RBG-47572

June 3, 2015

SUBJECT: Response to Request for Information - Change to Technical Specification  
3.8.1, "AC Sources – Operating"  
River Bend Station, Unit 1  
Docket No. 50-458  
License No. NPF-47

Table 8.3-3

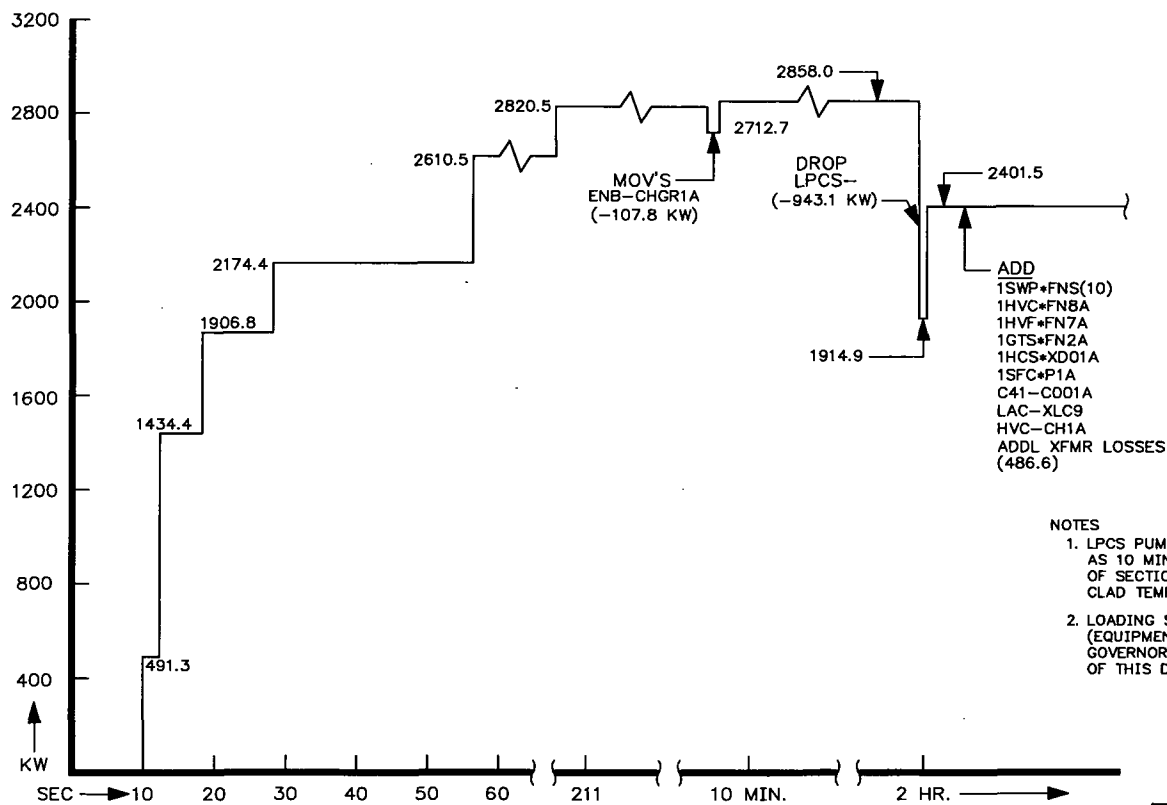
2. By the letter dated February 24, 2015, in response to RAI 5, the licensee stated that "The affected RBS USAR [Updated Safety Analysis Report] pages were updated as a result of updated EDG loading requirements." Please provide the affected USAR pages.

Description	EquipName	KVA		HP	Percent Load	Maximum Running	
		Connected				KW	
HPCS pump motor	E22-C001	2181.0	<del>2170.1</del>	2500.0	92.9	<del>95.0</del>	<del>1896.2</del> 1862.4
Margin	MCCS002-MARGIN		6.1			90.0	<del>4.7</del> 4.6
Gen. Vent Supply Fan	HVP-FN6C		1.5	1.0	90	<del>100.0</del>	<del>1.0</del> 0.9
120 VAC Dist. Pnl.	SCV-XDS002		15.0		19	<del>11.0</del>	<del>1.3</del> 2.3
Standby service water pump room vent fan	HVY-FN1C	7.6	<del>7.5</del>	7.5	100.0	<del>6.5</del>	<del>6.5</del> 6.6
HPCS pump & room Unit Cooler	HVR-UC5	49.4	<del>49.3</del>	50.0	75.2	<del>84.0</del>	<del>35.7</del> 32
Fuel Oil xfer pump	EGF-PlC		3.6	3.0	100.0		2.9
Gen. Battery Room Exhaust Fan	HVC-FN3F		2.0	1.5	100.0		1.5
Gen. Battery Room Exhaust Fan	HVC-FN3C		2.0	1.5	100.0		1.5
Misc. Motor Operated Valves		63.8	<del>67.6</del>		100.0		<del>60.0</del> 57.4
Turbocharger Lube Oil Pump	E22-S001ACP	1.4	<del>1.1</del>	0.7	100.0		<del>0.7</del> 0.9

DG Lube Oil Immersion Heater @ 480V	E22-S001GSH	3.3	<del>3.1</del>		100.0		3.3
120 VAC Dist Pnl.	E22-S002PNL		10.0		38		3.0
DG Battery Charger	E22-S001CGR		25.0		100.0		20.0
HPCS Discharge Line Fill Pump	E22-C003	4.8	<del>5.4</del>	5.0	100.0		<del>4.6</del> 4.3
DG Circulating Oil Pump	E22-S001COP	1.8	<del>1.6</del>	1.0	100.0		<del>1.1</del> 1.0
Transformer losses 225KVA @ 3.3%Z	E22-S003		7.4		100.0		6.7
DG IMRS heater @ 480V	E22-S001DGH		16.3		100.00		16.3
Total Initial Load			<del>2403.6</del>				<del>2067.8</del>
			2402.0				2027.56
20 second load Block							
DG Room Vent Fan (delayed approximately 20 sec from diesel start.)	HVP-FN3A		<del>90.7</del>	100.0	<del>94.0</del>		<del>76.0</del>

Figure 1 – Division I

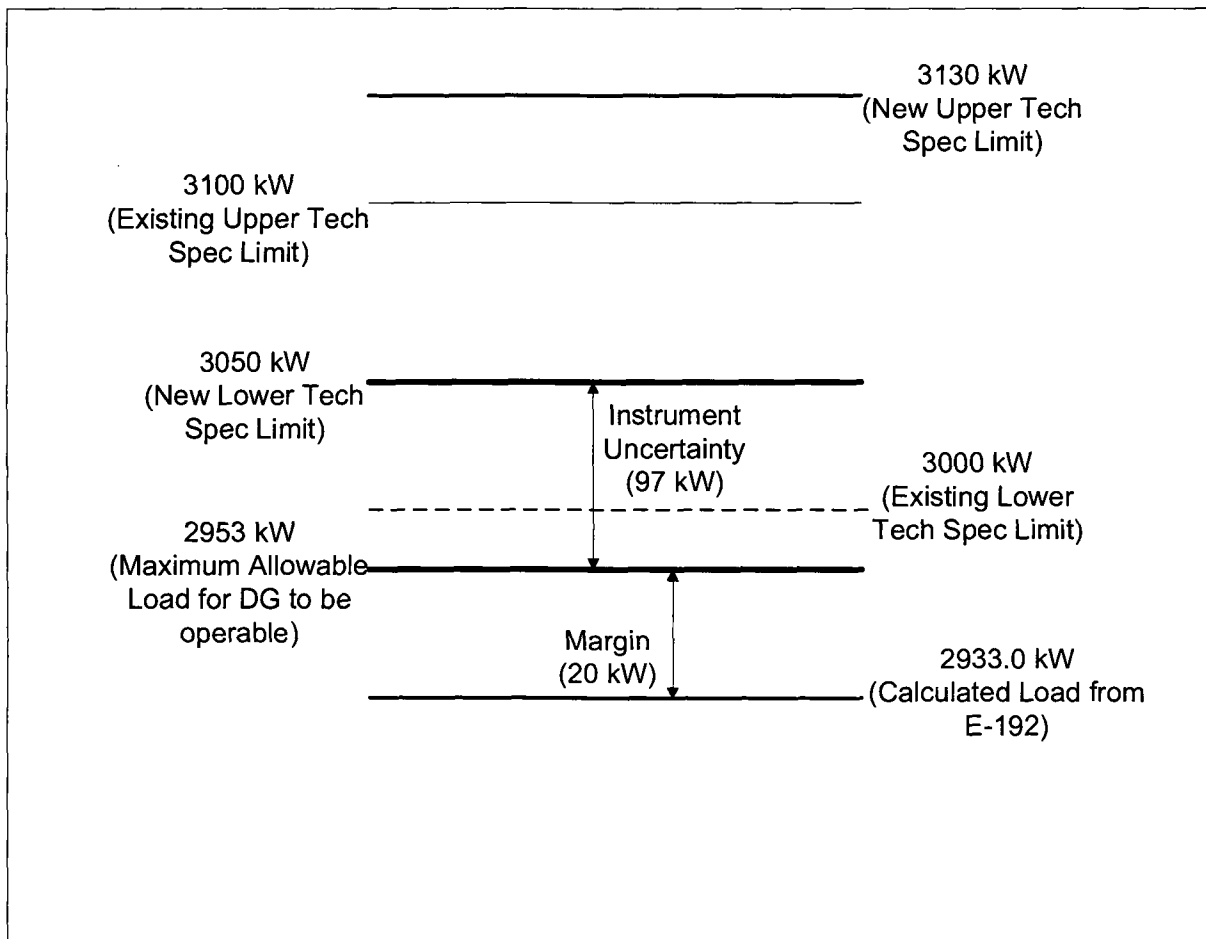
3. By the letter dated February 24, 2015, in response to RAI 7, the licensee references the "Engineering Change package." Please provide from the Engineering Change package relative information regarding this amendment.

Figures 1 and 2 as shown below provide the new test band in relation to the worst case loading scenario for the Division I and II Diesel Generators respectively. Since the proposed test loading is within the operating limit of the Diesel Generators and does not impose additional stress on the Division I and II Diesel Generators, the new test band is considered acceptable.
